2.5 Geology, Seismology, and Geotechnical Engineering

In Section 2.5, “Geology, Seismology, and Geotechnical Engineering,” of the VEGP SSAR, the applicant described geologic, seismic, and geotechnical engineering properties of the VEGP ESP site. SSAR Section 2.5.1, “Basic Geologic and Seismic Information,” presents information on geologic and seismic characteristics of the VEGP site and region surrounding the site. SSAR Section 2.5.2, “Vibratory Ground Motion,” describes the vibratory ground motion assessment for the ESP site through a PSHA and develops the SSE ground motion. SSAR Section 2.5.3, “Surface Faulting,” evaluates the potential for surface tectonic and non-tectonic deformation at the ESP site. SSAR Sections 2.5.4, “Stability of Subsurface Materials and Foundations,” 2.5.5, “Stability of Slopes,” and 2.5.6, “Erbankments and Dams,” describe foundation and subsurface material stability at the ESP site.

This SER, compiled by the NRC staff, is divided into six main sections, 2.5.1 to 2.5.6, which parallel the six main sections included in the applicant's SSAR. Each of the six SER sections is then divided into four sub-sections: (1) "Technical Information in the Application"

Figure 2.5.2-15 - Results of the staff's site response calculations for high-frequency rock motions for the 10^{-4} hazard level. The applicant's mean results are shown for comparison.

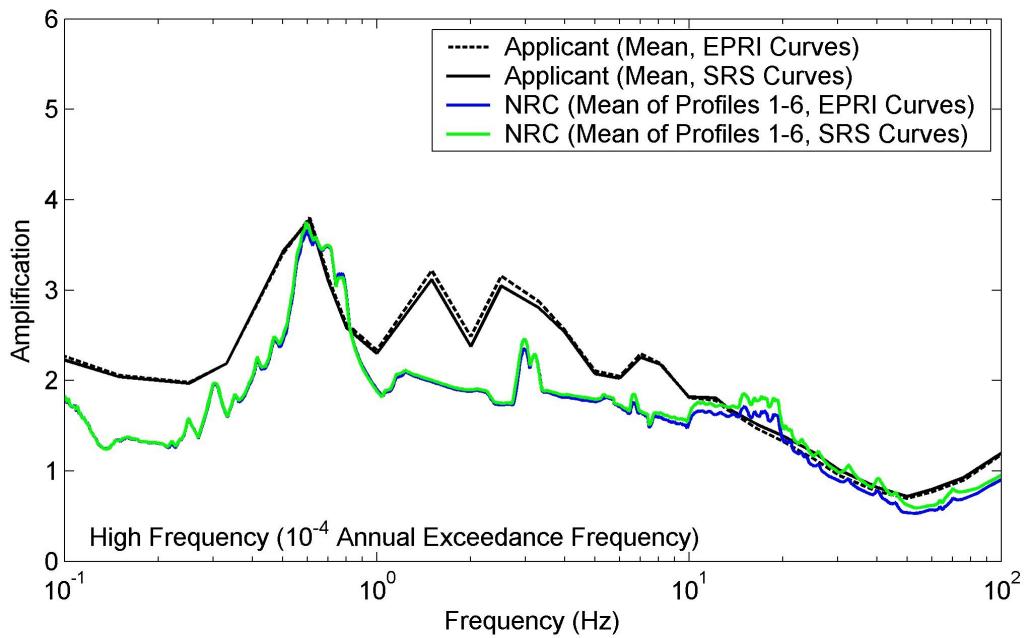
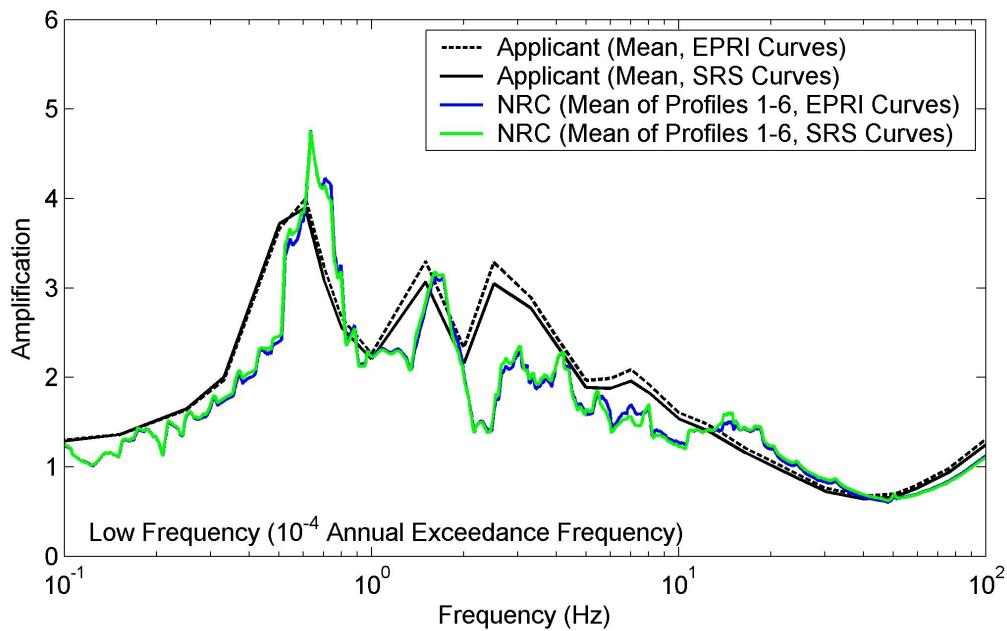
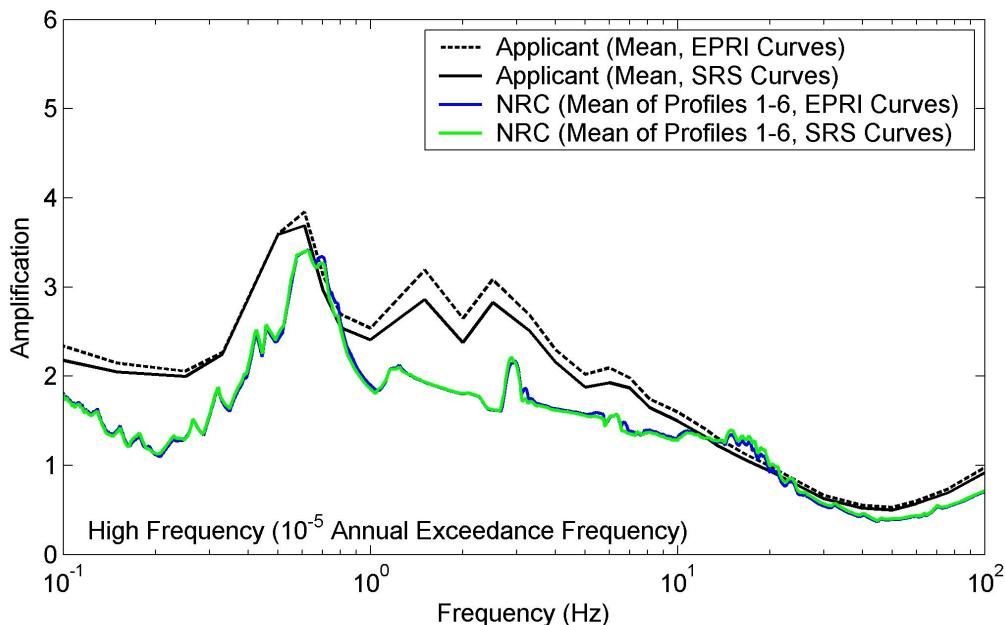
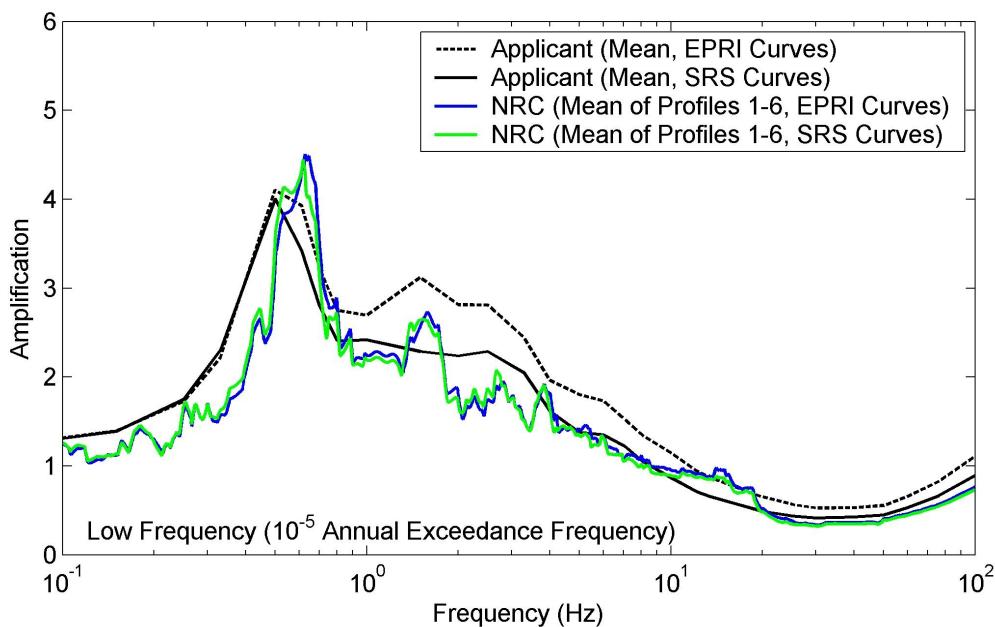
SER Figures 2.5.2-15 to 2.5.2-18 show the mean AFs resulting from the staff's confirmatory site response calculations. Each figure plots the mean results of the six alternative subsurface profiles for both the EPRI and SRS shear modulus and damping curves. SER Figures 2.5.2-15 and 2.5.2-16 show the results corresponding to the 10^{-4} hazard levels for the respective high- and low-frequency input motions, while SER Figures 2.5.2-17 and 2.5.2-18 plot the results corresponding to the 10^{-5} hazard levels for the respective high- and low-frequency input motions. SER Figures 2.5.2-15 to 2.5.2-18 also show the applicant's mean AFs for comparison. The applicant's results are similar overall. For each case, the

amplification peaks are very similar, and in all cases, the peaks occur at approximately 0.6 Hz. The differences between the results are likely due to the greater variability that the applicant incorporated into its model through the use of randomized profiles and material properties, as well as the use of multiple time histories. This variability is illustrated in SER Figure 2.5.2-19 (reproduced from SSAR Figure 2.5.2-37). As a result of its analysis, the staff was able to confirm the applicant's overall site response results.
